Authorized Field Change

AFC G-02908

Subject: 9200i, 9400i, and 9900i Models with Cummins ISX Engines and Leece Neville Starters, International Codes 08WWM and 08WTB, Built at Escobedo Before August 27, 2002 and at Chatham Before August 29, 2002 have Incorrect Starter Nose Cone Housings

Figure 1 Remove Starter Motor Nose Cone Housing

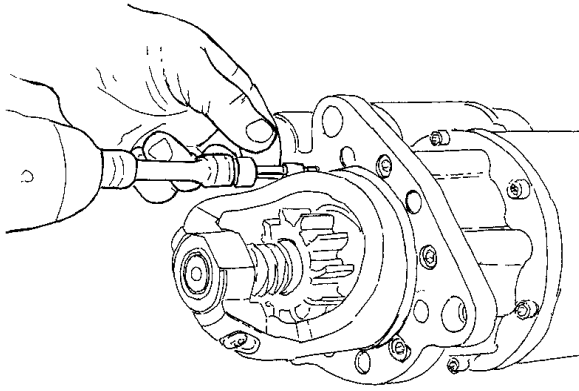
1. Disconnect the negative cable from the battery.
2. Disconnect power and ground cables from the starter motor.
3. Remove starter motor mounting bolts and remove starter.
4. Place the starter motor on a work bench and remove the nose cone housing mounting bolts (Figure 1) .

Figure 2 Verify Washer is on the Shaft (Arrow)

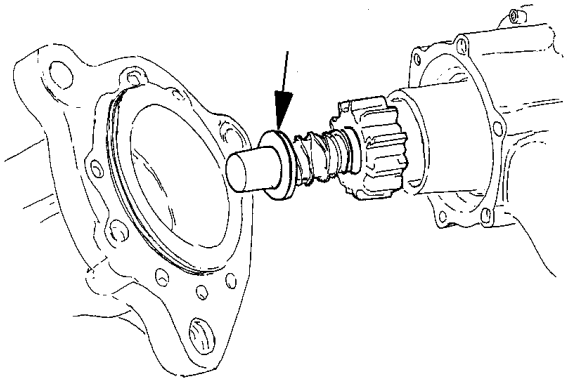
5. Remove the nose cone Housing. Verify the washer is still on the shaft (Figure 2).

NOTE – Do not reuse the removed nose cone housing, scrap locally.

Figure 3 Flange Mounting Hole (Arrow) Aligned with Solenoid Housing Mounting Bolt Shown in the Background When Viewed Through the Flange Mounting Hole

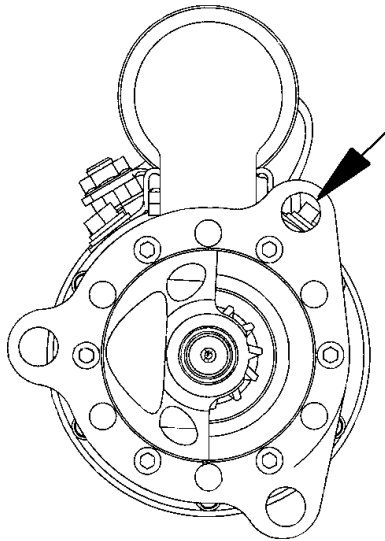
6. Install the new nose cone housing. Align the flange as shown in Figure 3. When the nose cone housing flange is correctly aligned, the flange mounting hole, arrow in Figure 3 , will be approximately in line with the solenoid housing mounting bolt. Placing a screwdriver through the flange hole in line with the solenoid mounting bolt (Figure 4) may be helpful to guide to align the nose cone housing flange.

Figure 5 Attach New ID Label

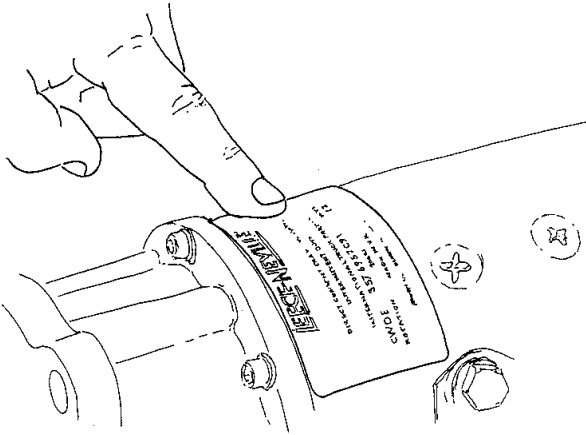
7. Apply Loc-Tite 242 to the nose cone housing mounting bolts and tighten to 25 Lbf-ft (34 Nm).
8. Verify the starter motor is free to rotate counter clockwise.
9. Remove the starter identification label and replace with a new label from the service kit. Refer to Table 2 for the correct label to use for the starter motor being serviced (Figure 5).

Old ID Label	New ID Label
3576959C91	3588403C91
3576960C91	3584402C91

Figure 6 Installing Rubber Seals (Arrow)

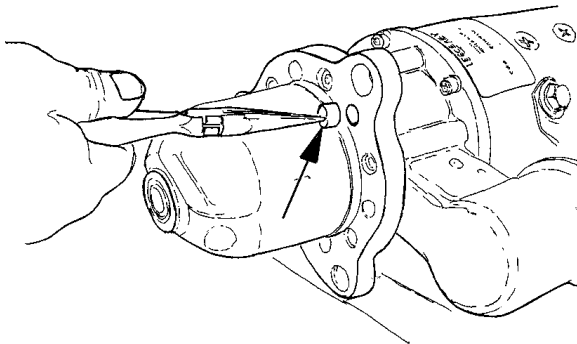
10. Remove the rubber seals from the old nose cone and install into the unused bolt holes in the new nose cone (Figure 6).
